## Amesbury Elementary School

# Amesbury School Building Committee December 17, 2020

## Parking Lot Landscaping | Revised (No Waiver)

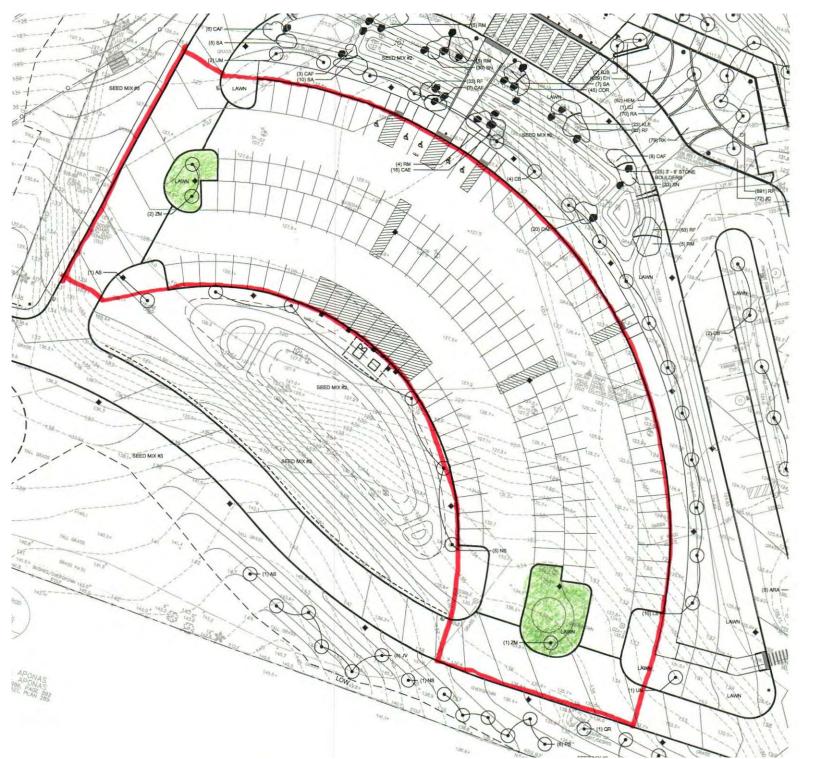
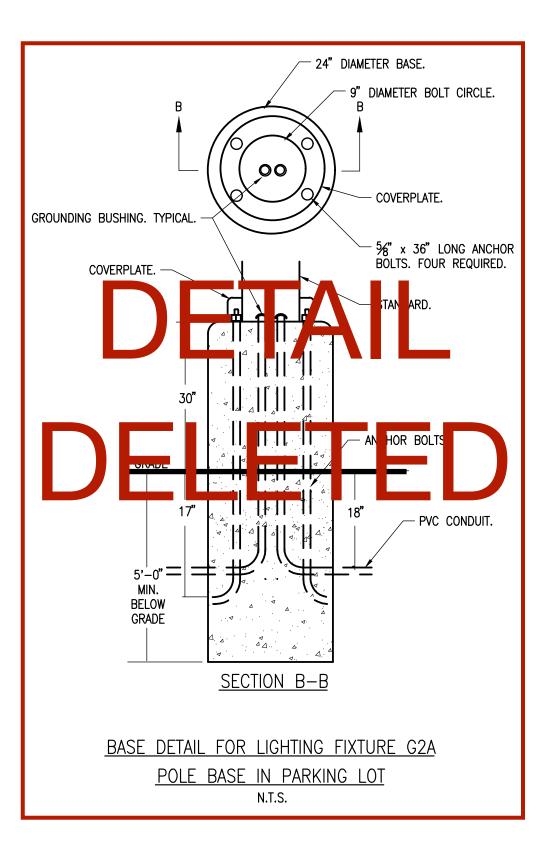
#### Previously Proposed:

# LandscapeReq'dProposed% of landscaped Area5%Total Parking Area AES (SF)56,787Total Landscape Area AES (SF)2,8395,334 (9.4%)Total Parking Area CES (SF)30,475Total Landscape Area CES (SF)1,5244,988 (16.4%)

#### Revised Proposed:

## Revised | Parking Lot Base Mounting Details

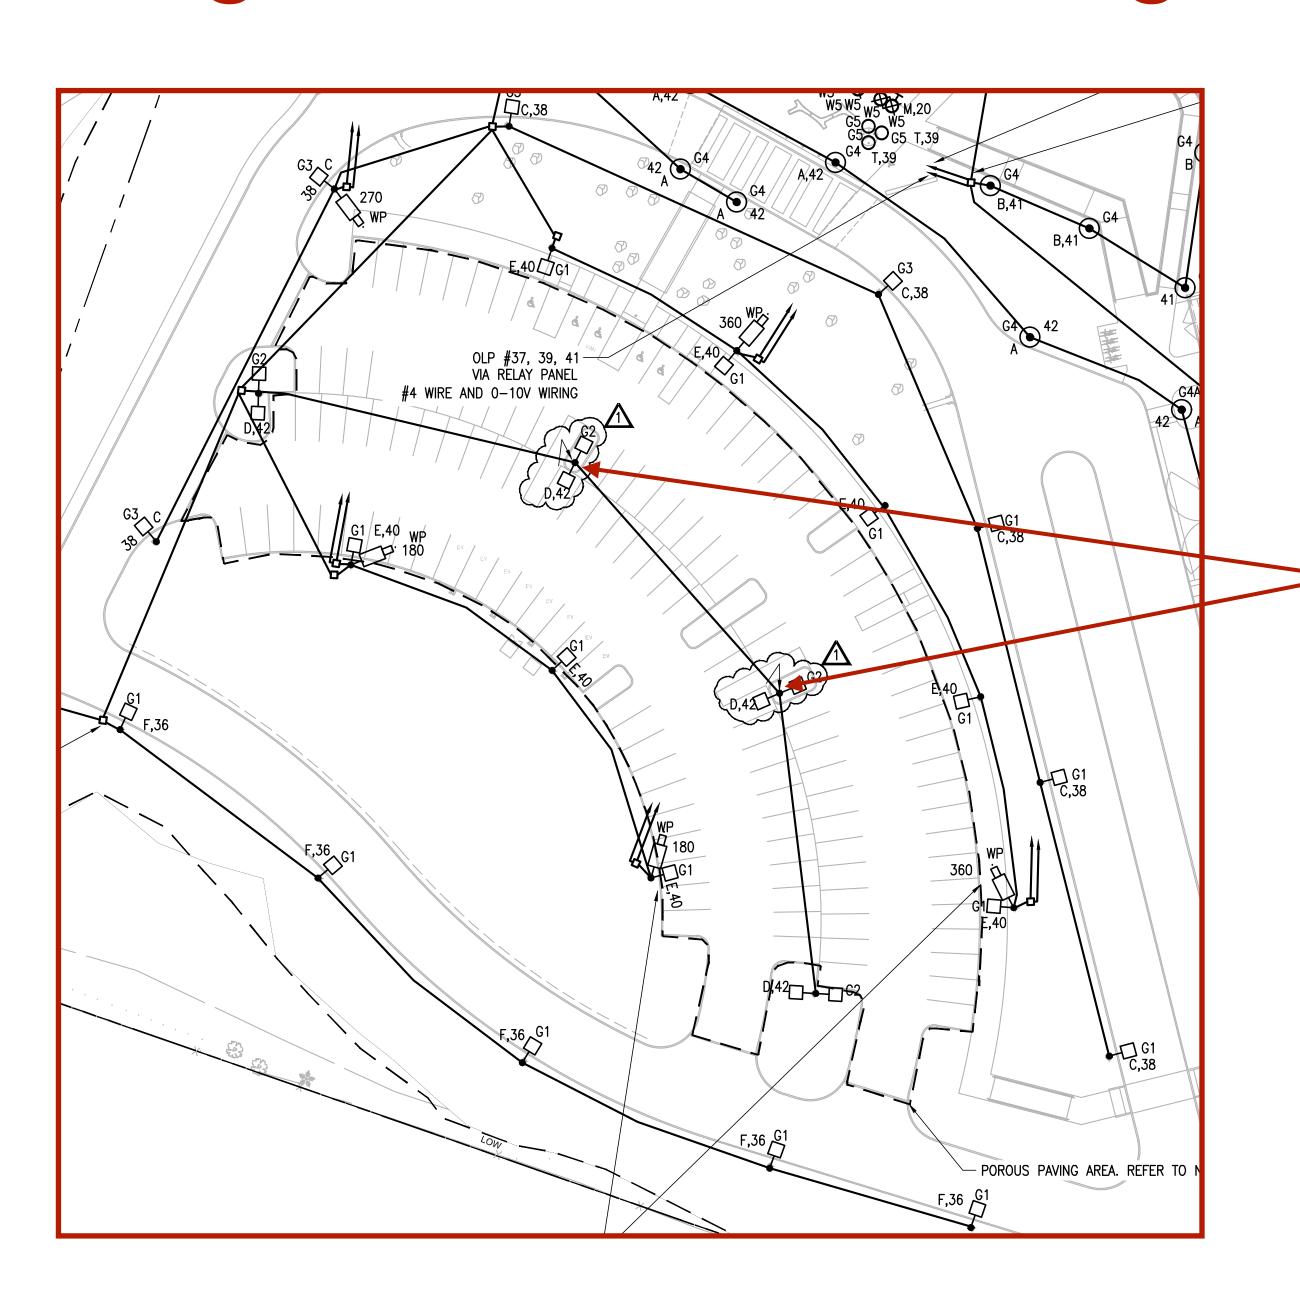
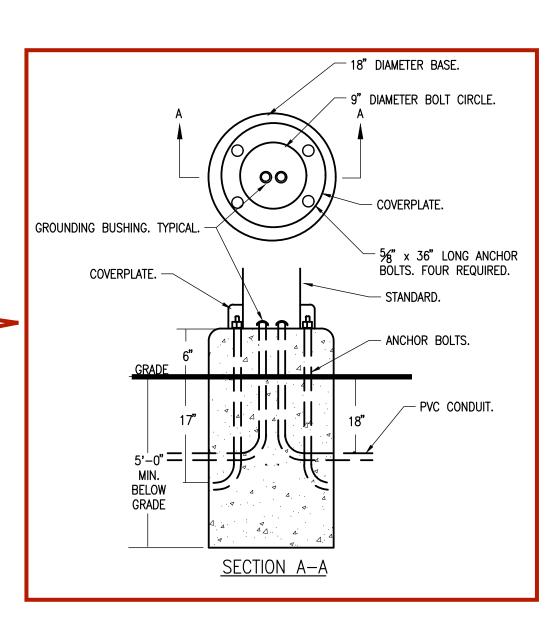
Previously Proposed Without Islands

## Typical Base: 6" above grade

Located on Islands

## Waiver Request 2 | Zoning Bylaw Section VIII.G.17

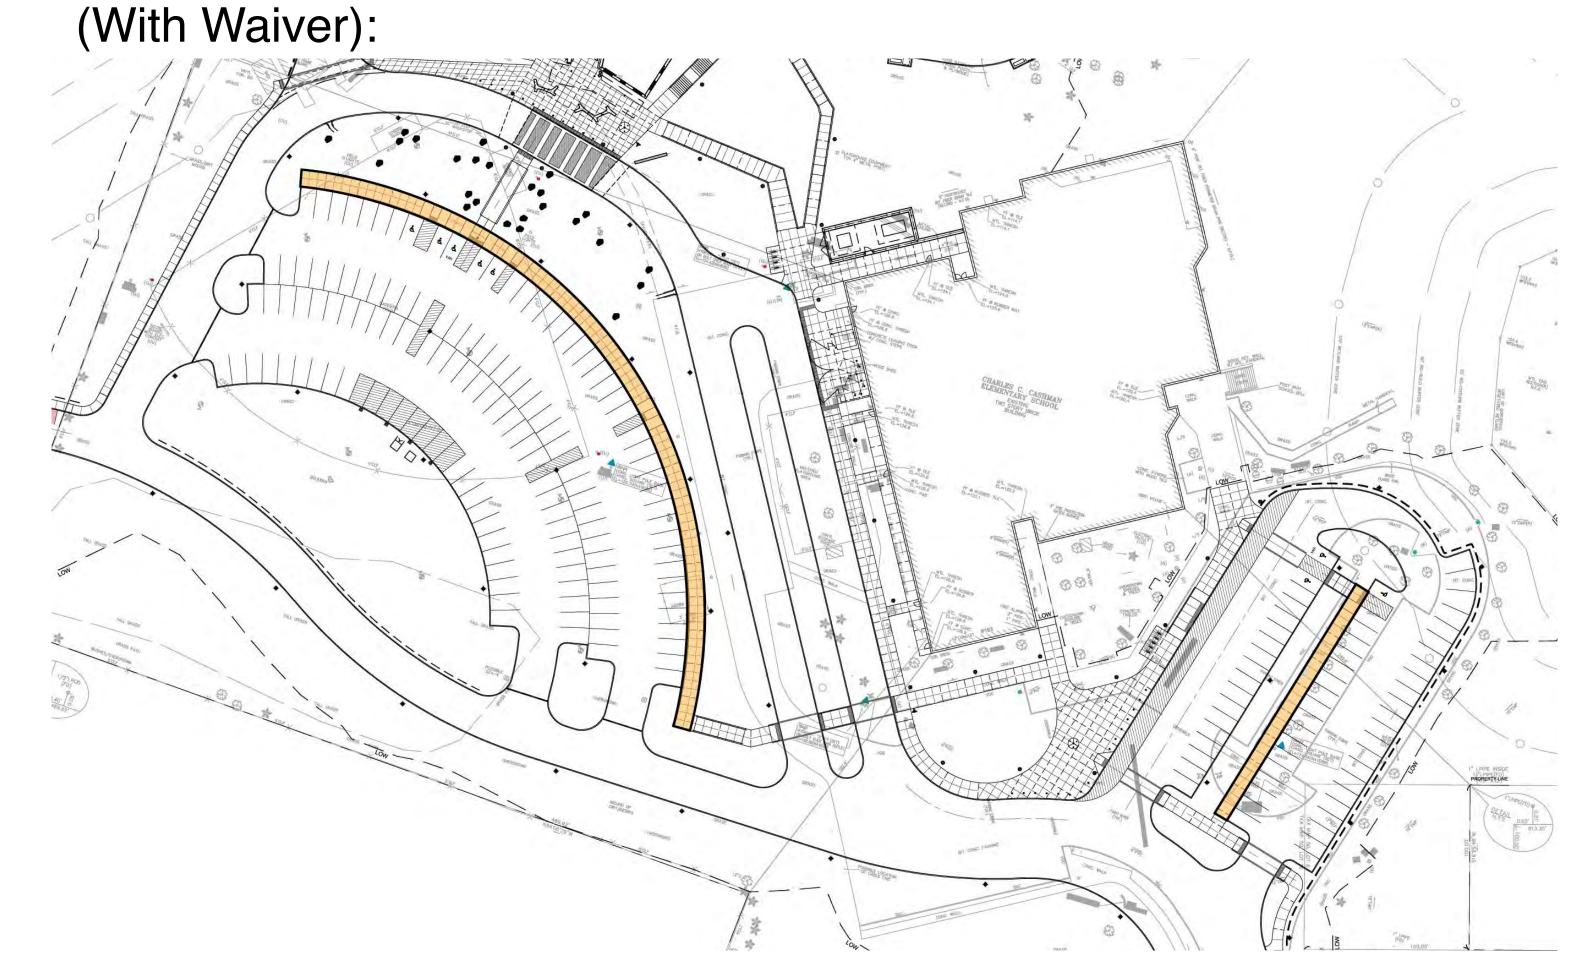
AES: The sidewalks abuts the curb. The curb is (6) inches wide and the sidewalk is (10) feet wide for a total of (10) feet (6) inches. With the (3) foot wide overhang for the vehicle there is a clear path of (7) feet (6) inches for pedestrians.

CES: The sidewalks abuts the curb. The curb is (6) inches wide and the sidewalk is (8) feet wide for a total of (8) feet (6) inches. With the (3) foot wide overhang for the vehicle there is a clear path of (5) feet (6) inches for pedestrians.

The DPW has stated that they would prefer that the paving extend to the curb and the sidewalk be widened to accommodate pedestrian movement for ease of maintenance and snow plowing.

## Waiver Request 2 | Parking Lot Sidewalk w/ Paint

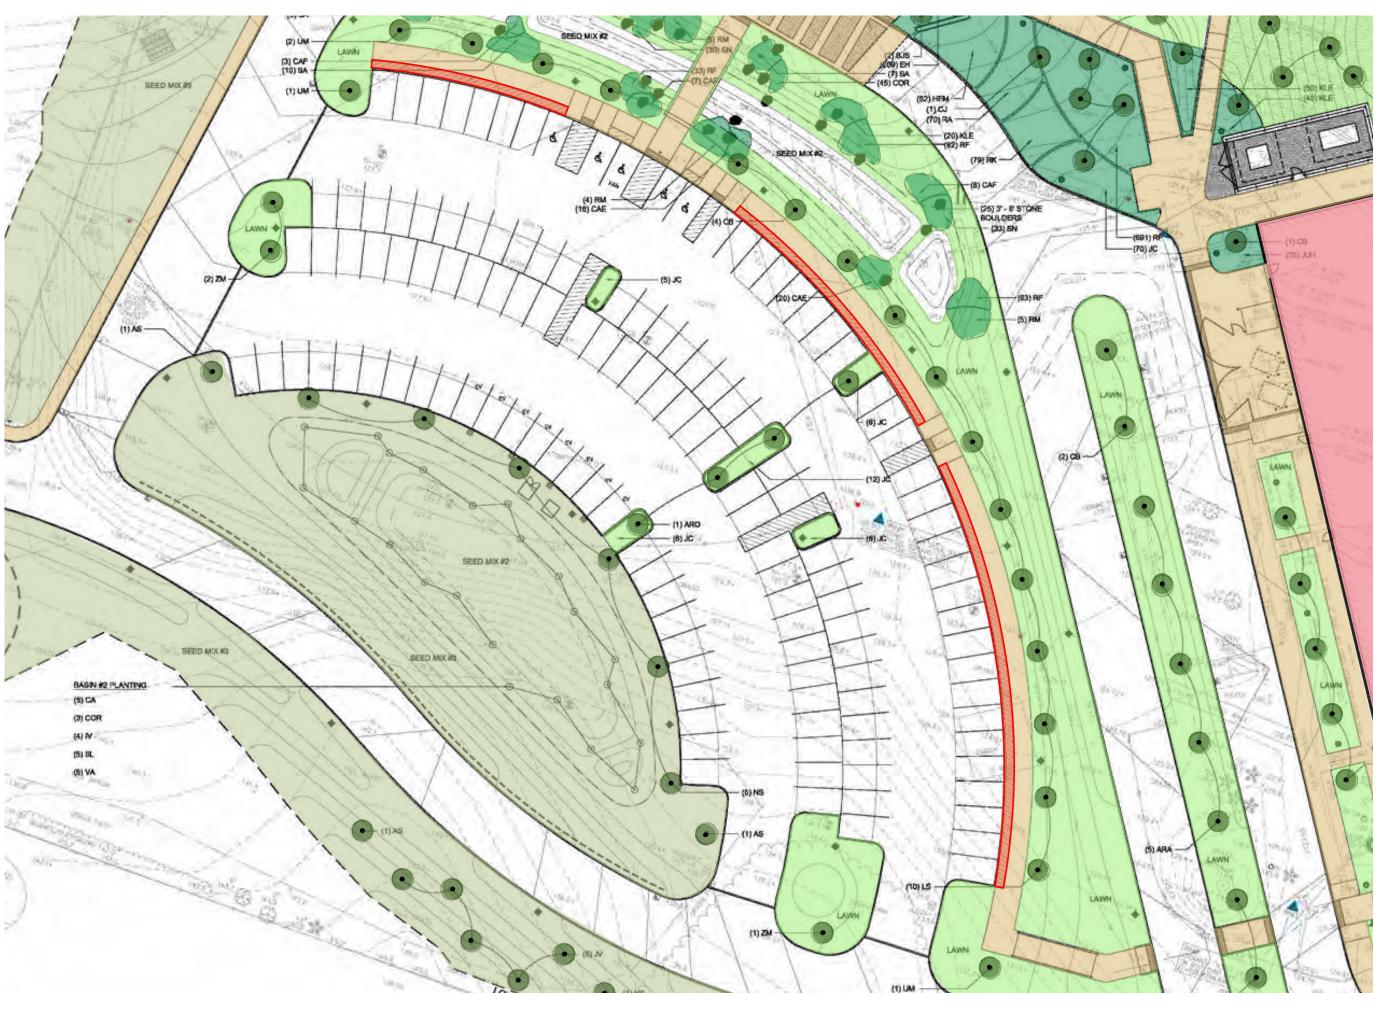
AES: Ten (10) feet of paved area abuts the curb. The curb is 6" wide. Both the curb and 2'-6" of the paved area directly adjacent to the curb (edge of parking) will be painted to denote vehicle overhang area that is not intended for pedestrians. The remainder of unpainted paved area is the dedicated sidewalk at path 7'-6" for pedestrians.

CES: Eight (8) feet of paved area abuts the curb. The curb is 6" wide. Both the curb and 2'-6" of the paved area directly adjacent to the curb (edge of parking) will be painted to denote vehicle overhang area that is not intended for pedestrians. The remainder of unpainted paved area is the dedicated sidewalk at path 5'-6" for pedestrians.

This provides a visual separation of vehicle and pedestrian zones and also meets the DPW's preferred design for ease of maintenance and snow plowing.

### Waiver Request 3 | Pipe Material & Cover

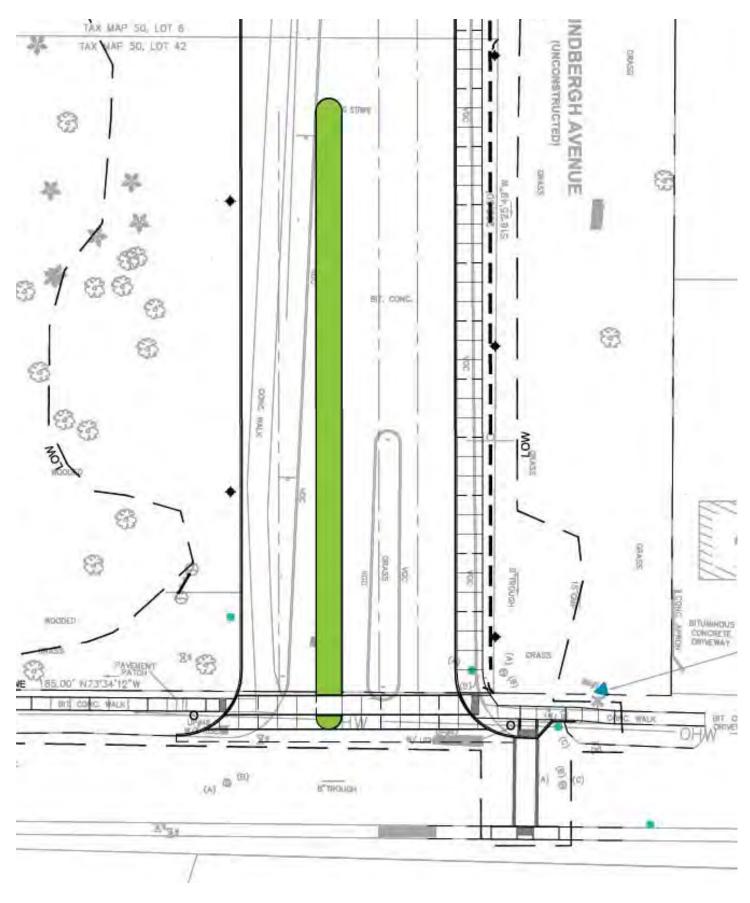
The project is proposing to use HDPE pipe for all drainage pipe. There are only a few isolated incidents where there will be less than 3 feet of cover over the drainpipes. Please note that there is a minimum of 2.5 feet of cover over the pipes with less than the 3 feet required.

After consulting with the City of Amesbury DPW, they are in favor of the HDPE pipe material. DPW regularly uses this pipe throughout the City and acknowledges the benefits of designing a costconscious system with modern pipe materials.

<sup>\*\*</sup>Peer Review Update - at areas of 2.5 feet cover, RCP will be used

## Entry Drive Design | Peer Review 1 Update

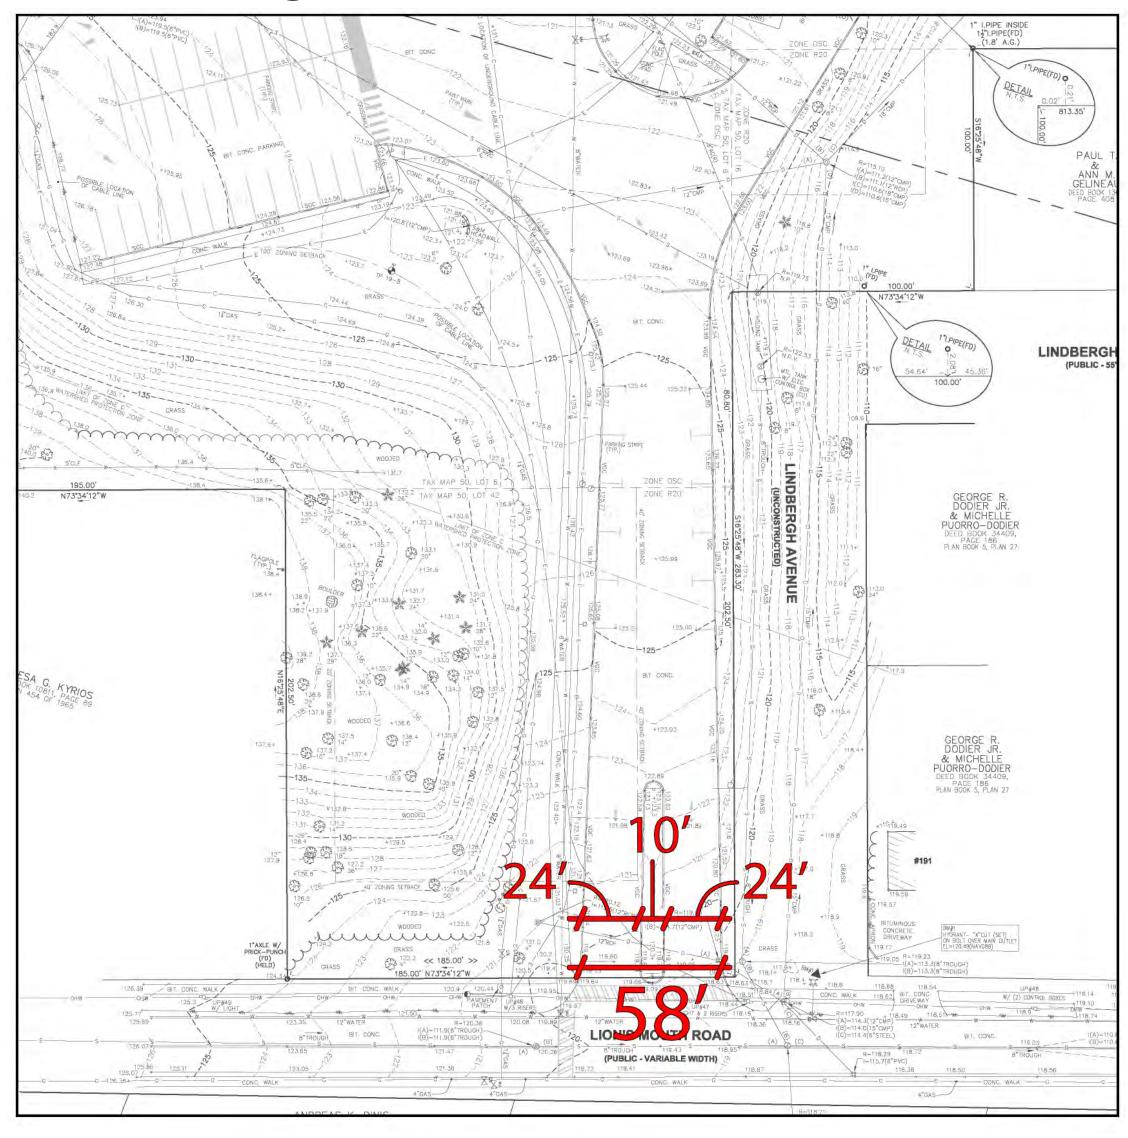
2 lanes for exiting - 23' wide

1 lane for exiting - 20' wide (to accommodate emergency vehicles)

## Entry Drive Design | Proposed Revision

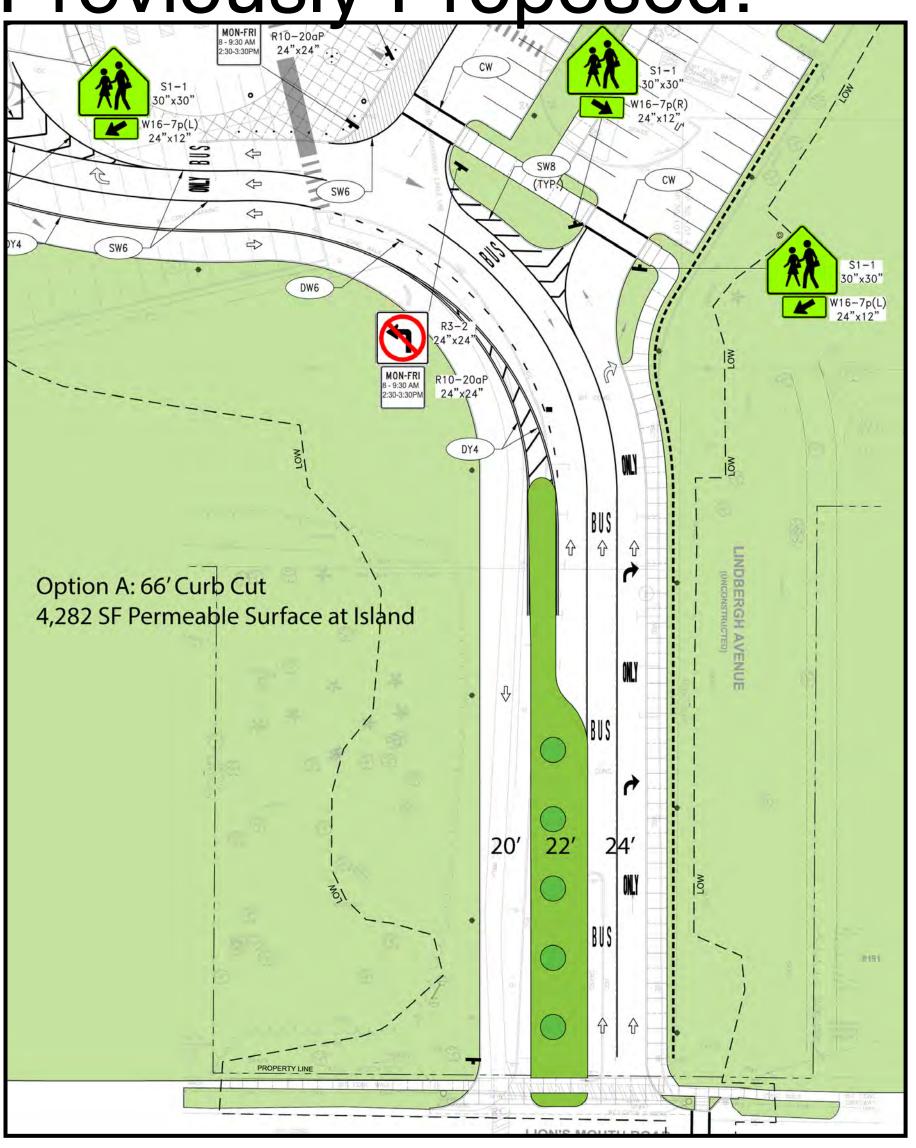
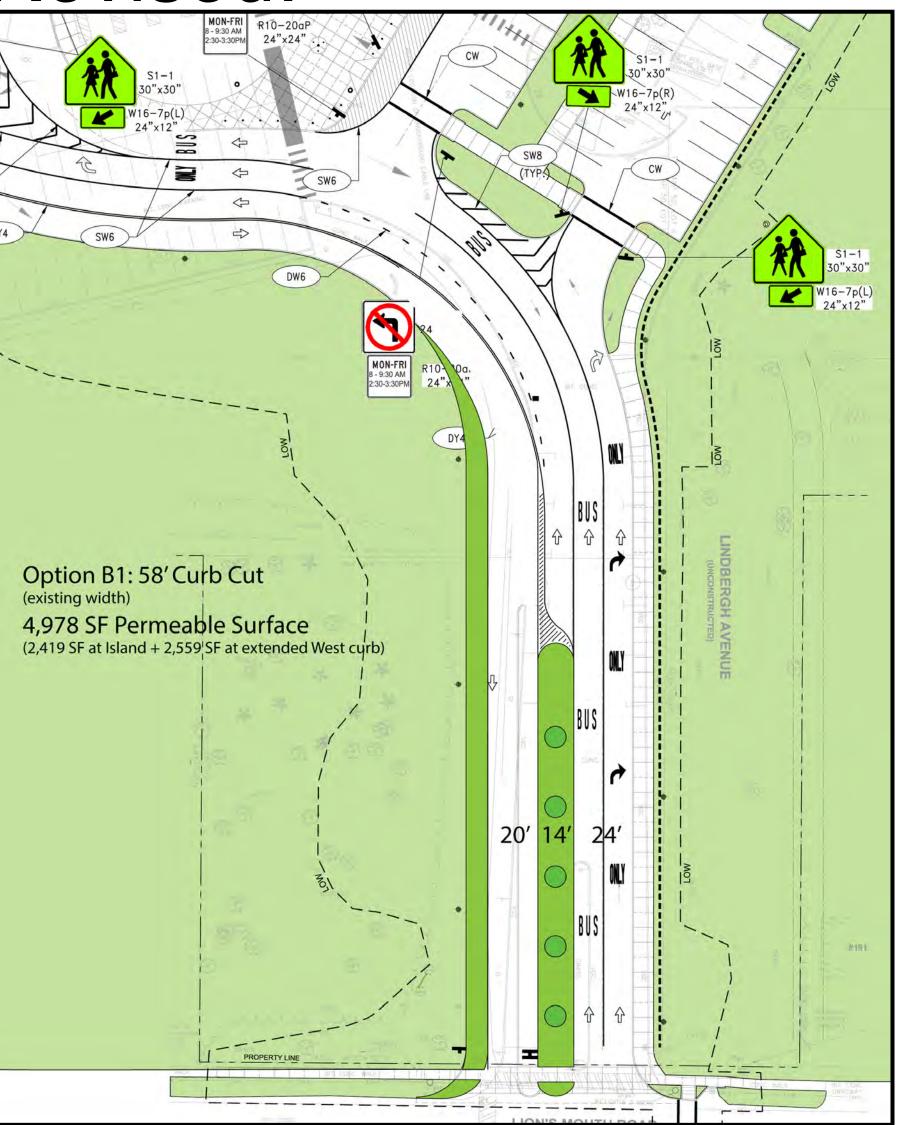
Previously Proposed:

#### Revised:
